ADDENDUM NO. 01

Project: **2024 Jersey Village High School Renovation**
Cypress-Fairbanks Independent School District

Issued by: Texas Arcadis Inc.
P.O. Box 891209
Houston, Texas 77289
281-286-6605

Texas Arcadis Inc.
Project No.: 202319

A0.07
 AREA 'G1' 1ST FLOOR DEMO PLAN

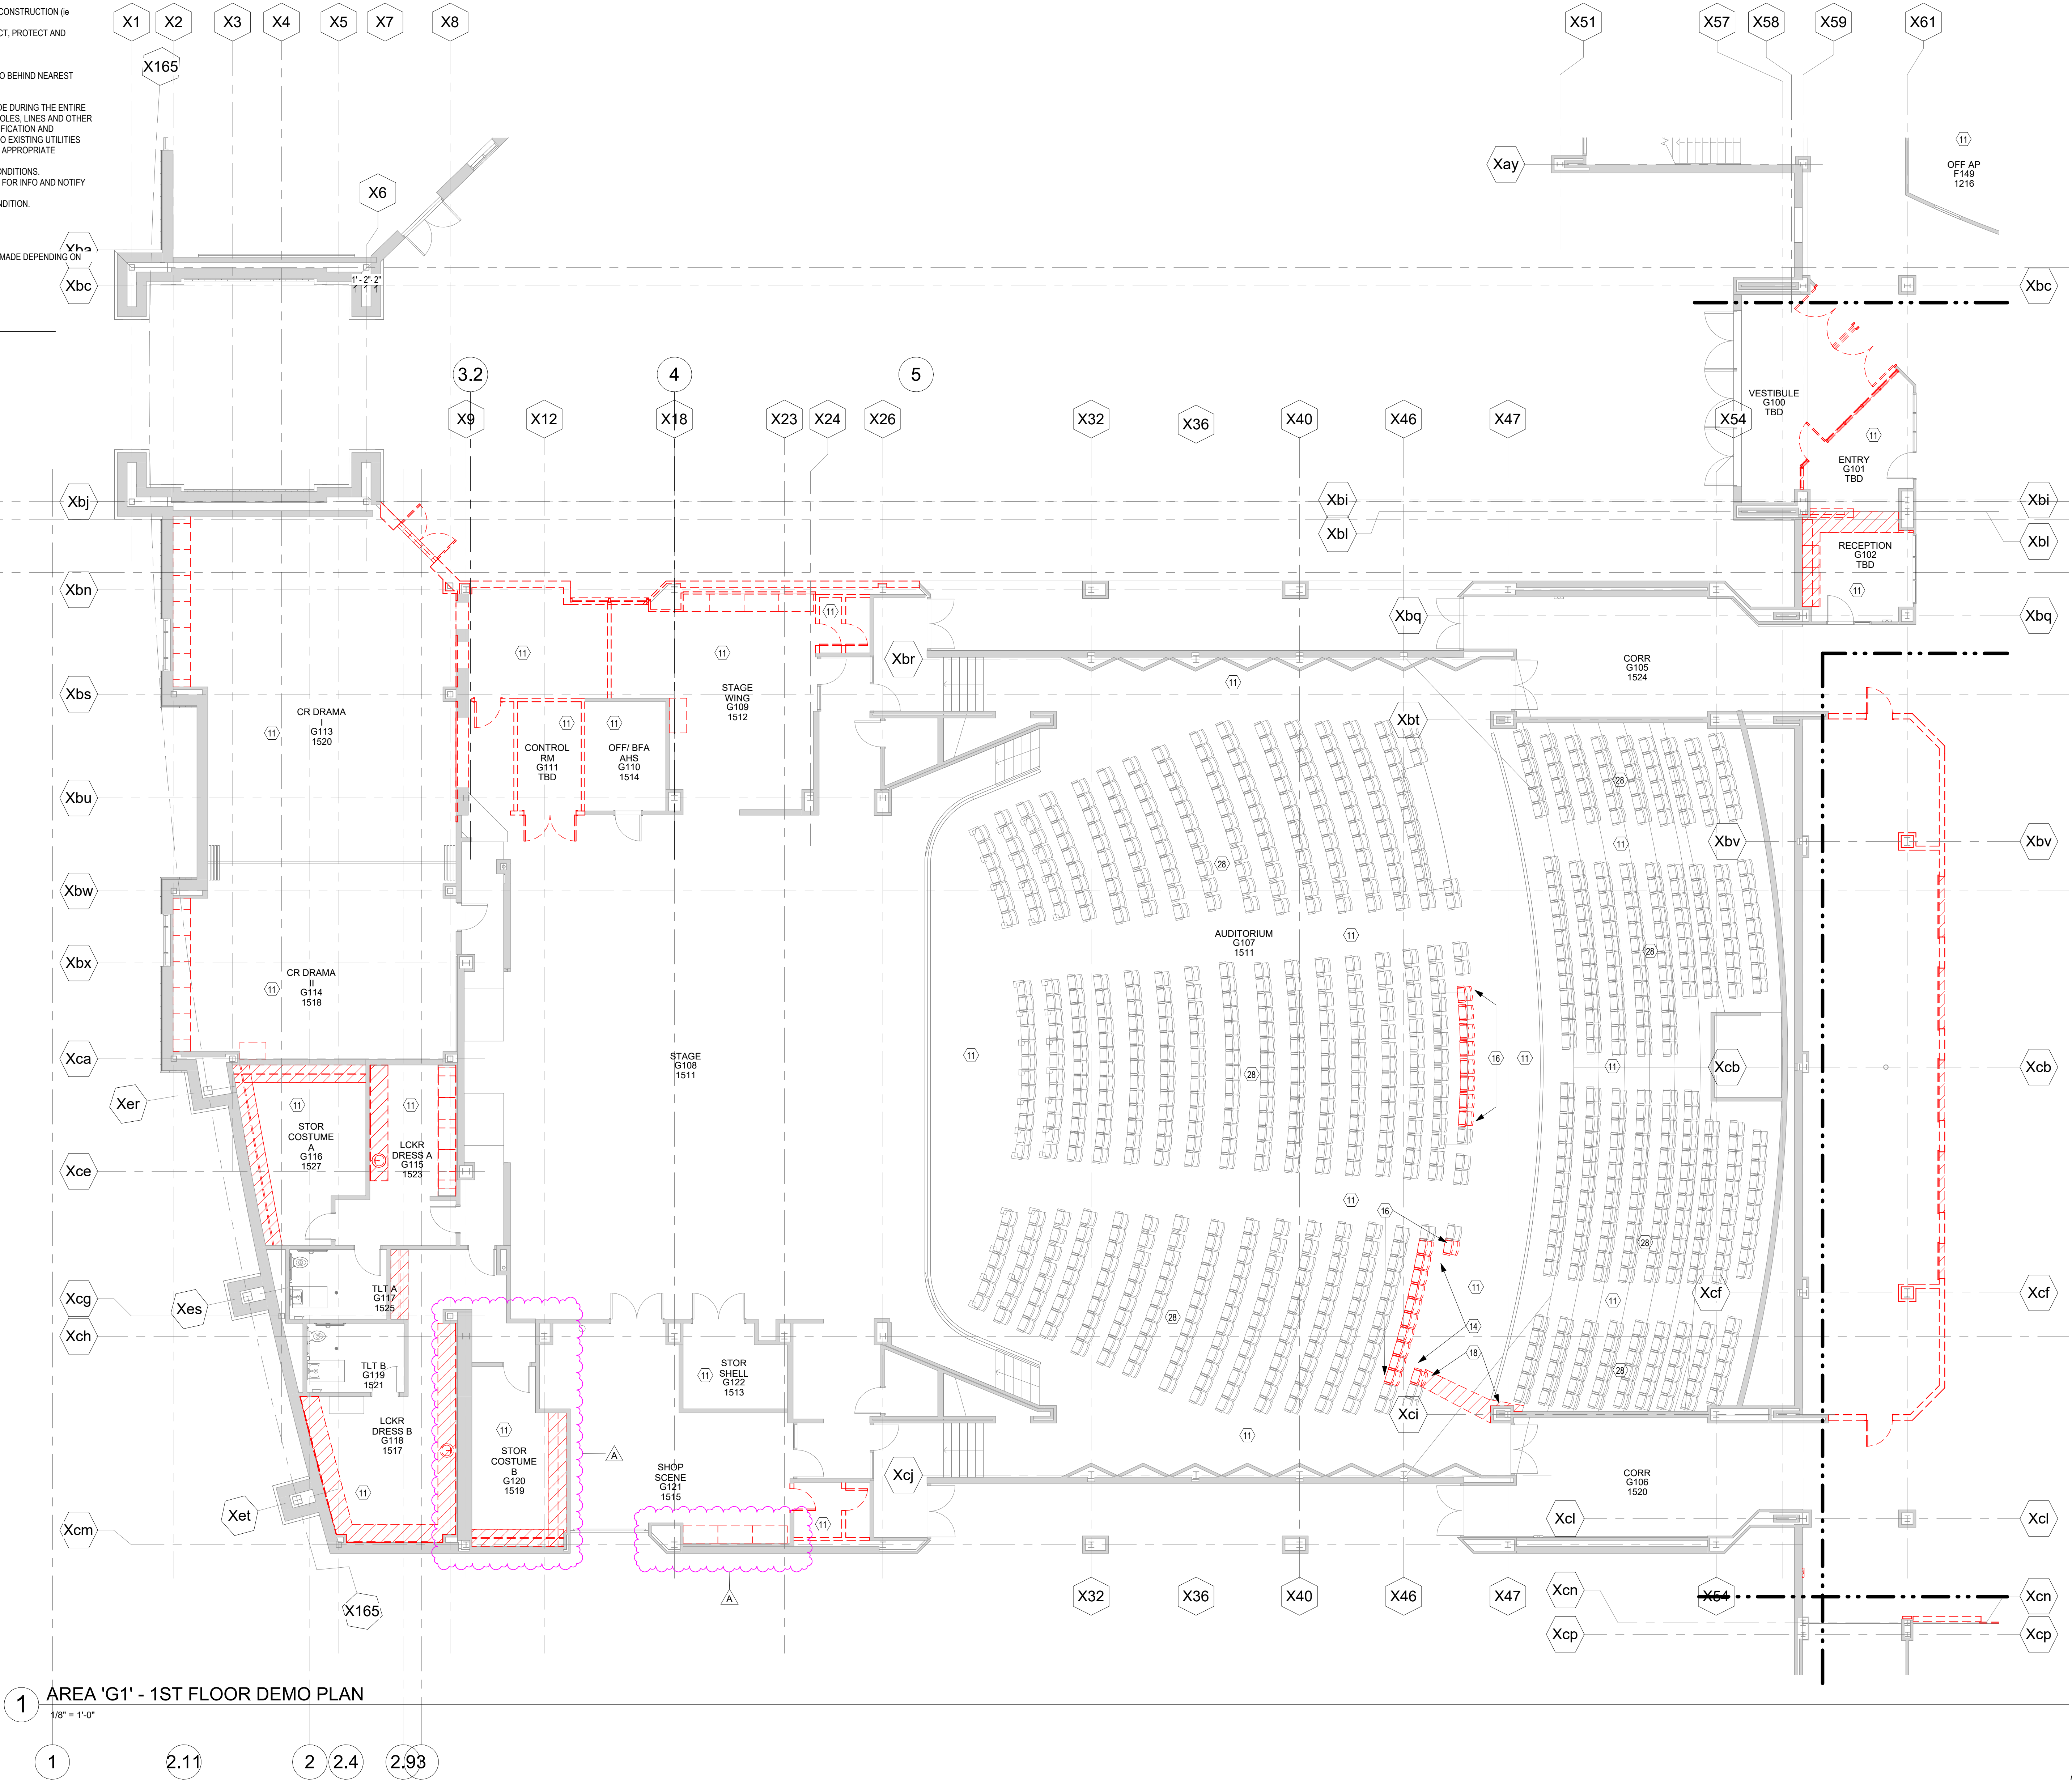
55. Sheet A0.07 - Area “G1” 1nd Floor Demo Plan
 - a. Revise G120 “STOR COSTUME” demolished casework
 - b. Revise G121 “SHOP SCENE” demolished casework
56. Sheet A0.10 - Area “K1” 1st Floor Demo Plan

A0.10
 AREA 'K1' 1ST FLOOR DEMO PLAN

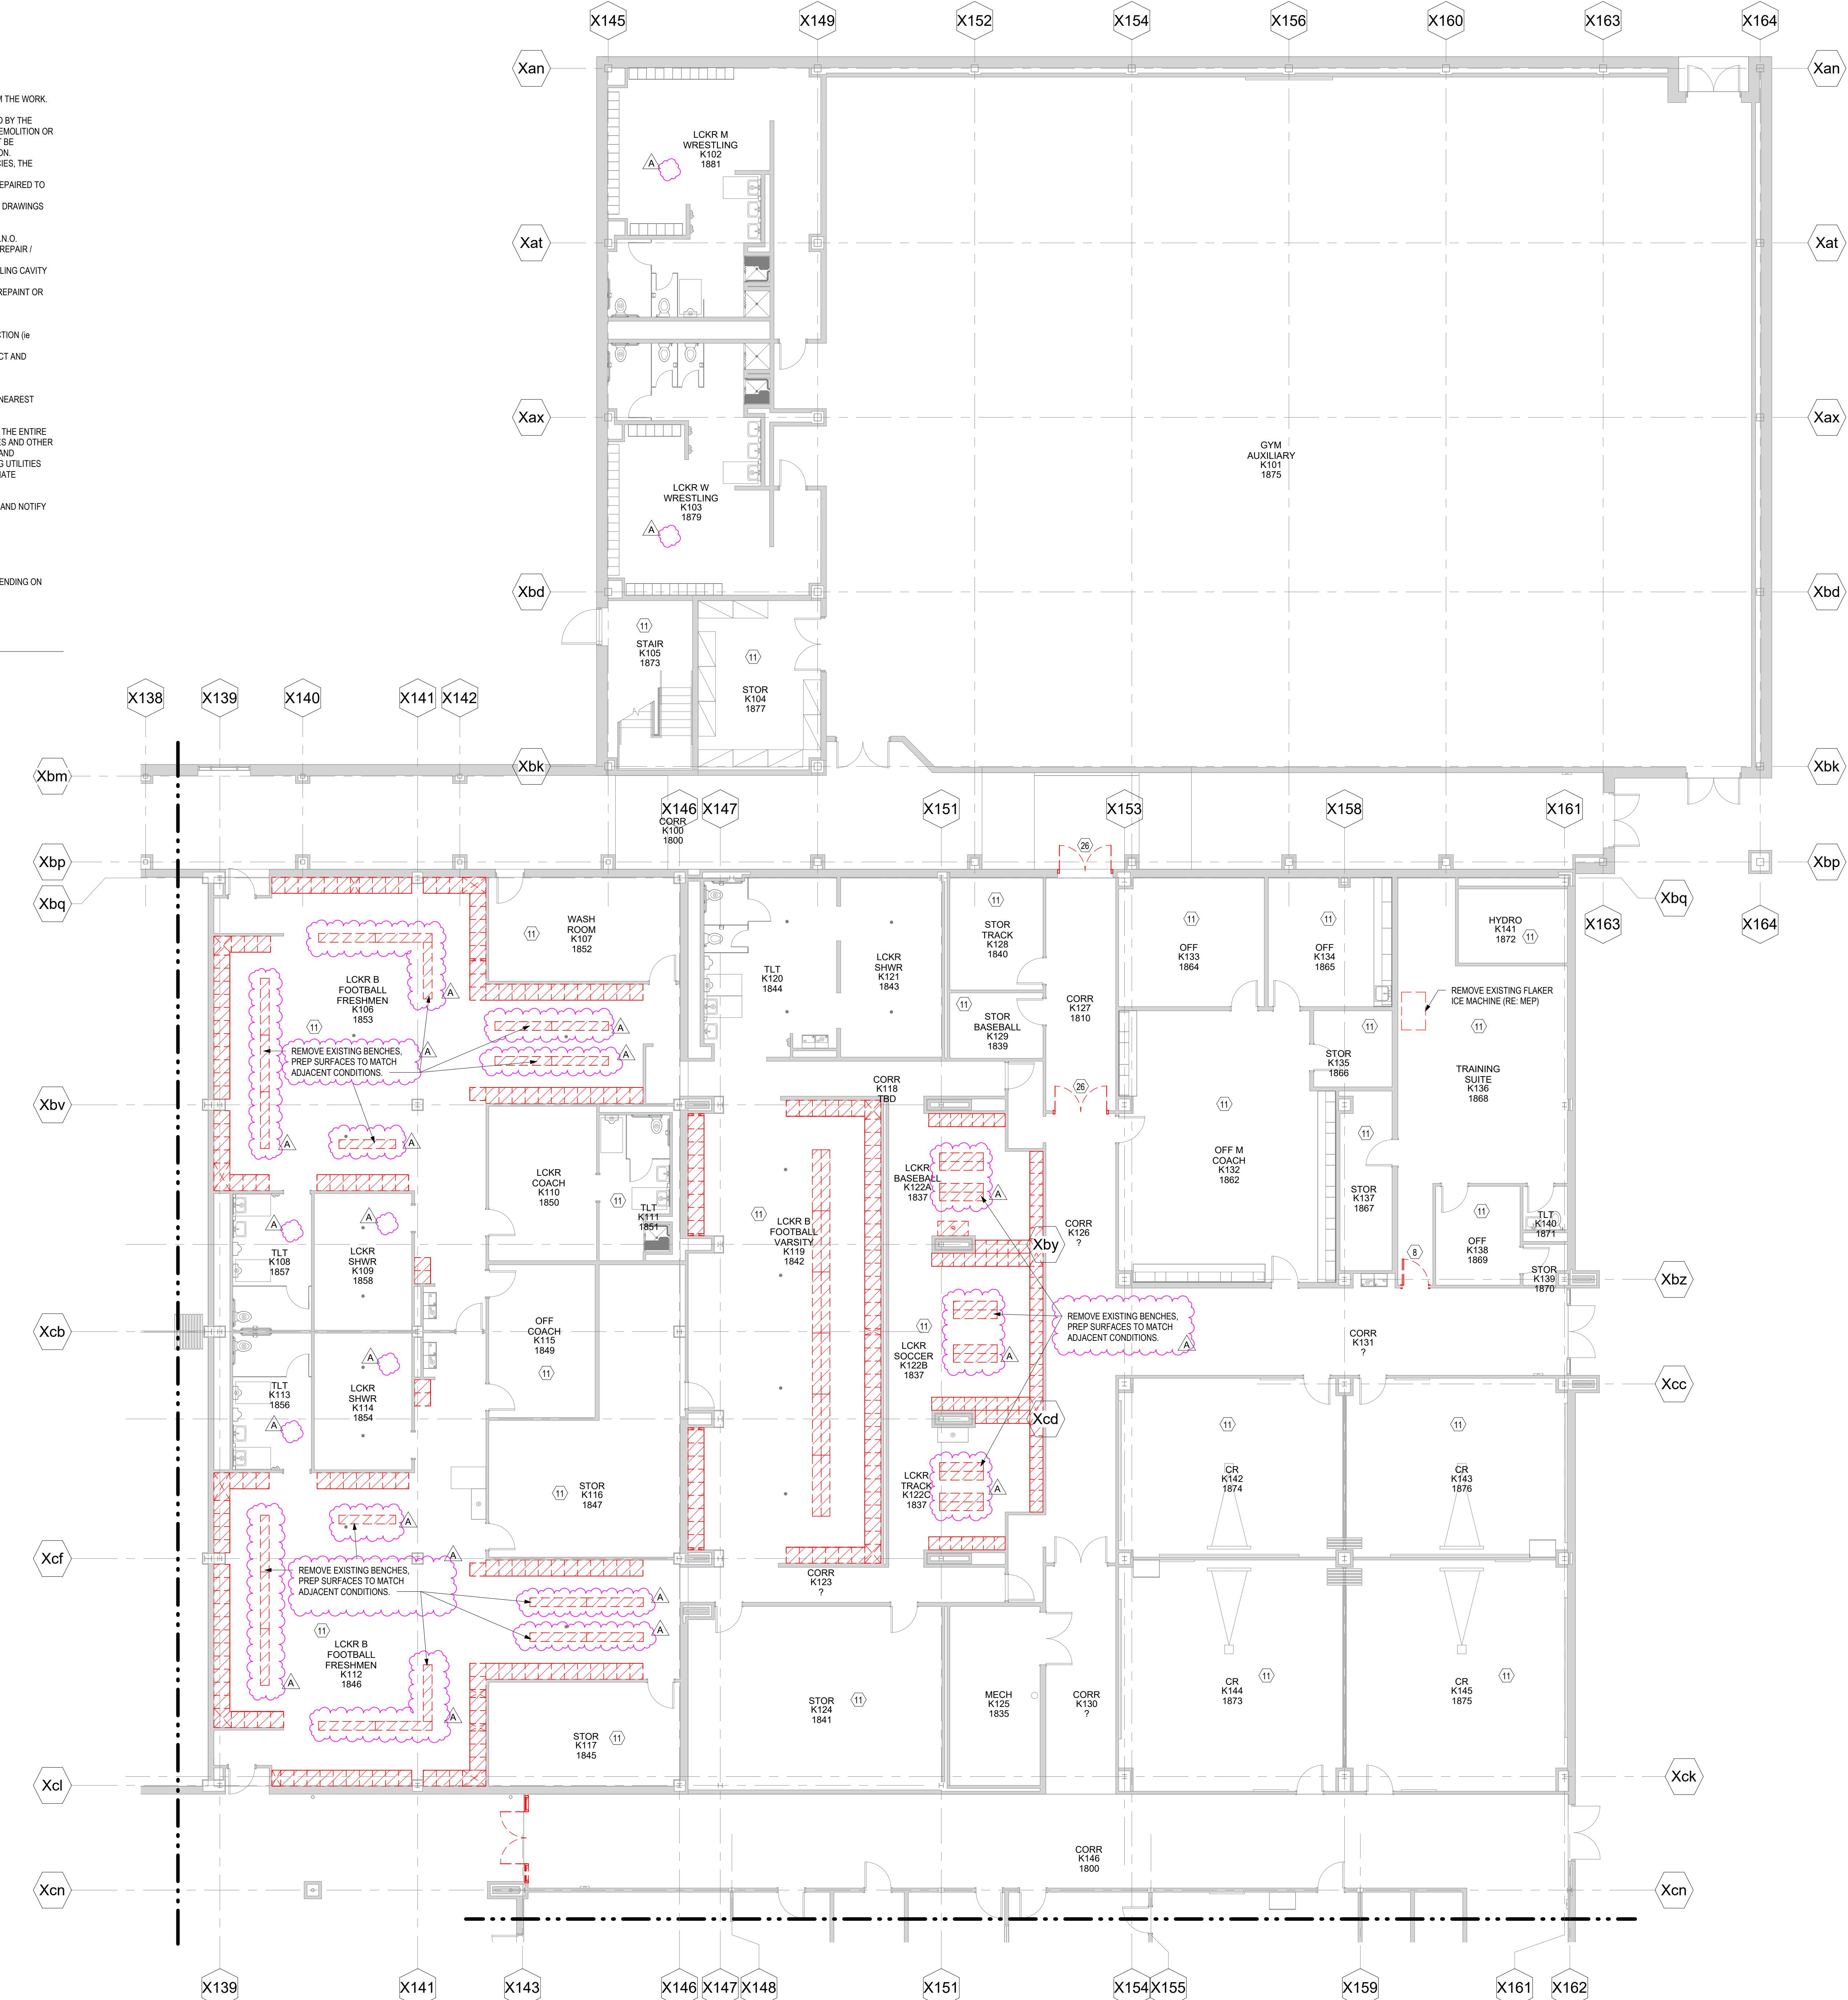
- a. Revise demo scope per reissued sheet.
57. Sheet A0.13 - Area “N1” 1nd Floor Demo Plan
 - a. Revise N110 “CR PHOTO”, N115 “CR PHOTO”, N11 “CR PHOTO” and N112 “CR PHOTO” demolished casework.
